# SERVICE BULLETIN

**Service Bulletin No. / Date:** SB TMG 125-1019 P1, Revision 1 / September 15, 2015

**Subject:** Integral Exhaust Manifold

**Type affected:** TAE 125-02-99 and TAE 125-02-114

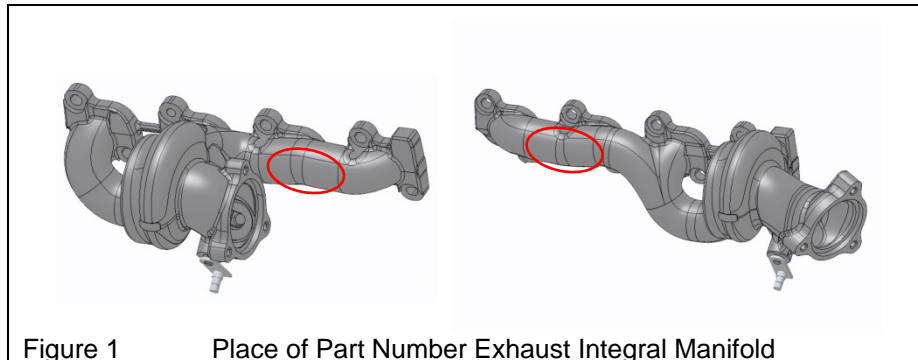
If the engines have Exhaust Integral Manifold  
P/N 05-7241-K0176xx or P/N 05-7241-K0178xx  
See Figure 1.

**Reason:** Cases of High Cycle Fatigue (HCF) of turbocharger turbine blades were reported to Technify Motors GmbH.

Installation of exhaust integral manifold P/N 05-7241-K023801 or P/N 05-7241-K023901 in accordance with RM-02-02, Chapter 72-40.03, Issue 3, Revision 2 or later approved revisions.

Installation of exhaust integral manifold P/N 05-7241-K023801 or P/N 05-7241-K023901 in accordance with RM-02-02, Chapter 72-40.03, Issue 3, Revision 2 or later approved revisions and turbocharger P/N 05-7241-K018703, 05-7241-K020302 or 05-7241-K019402 in accordance with RM-02-02, Chapter 72-40.01, Issue 3, Revision 1 or later approved revisions.
